To: T10 Serial Attached SCSI PHY Working Group
From: Russ Brown
Email: russ_brown@maxtor.com
Contact: Mark Evans
Email: mark_evans@maxtor.com
408-894-5310
Date: 30 October 2002

Subject: SAS driver and receiver electrical characteristics additions

Figure xxa. Transmitter transient test circuit

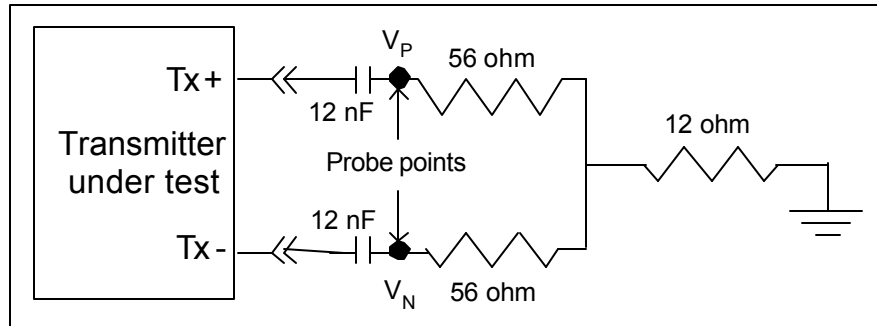
^d The maximum transmitter and receiver transients are measured at nodes V_P and V_N on the test loads shown in figures xxa (for the transmitter) and xxb (for the receiver) during all power state and mode

Add the following figures after the table:
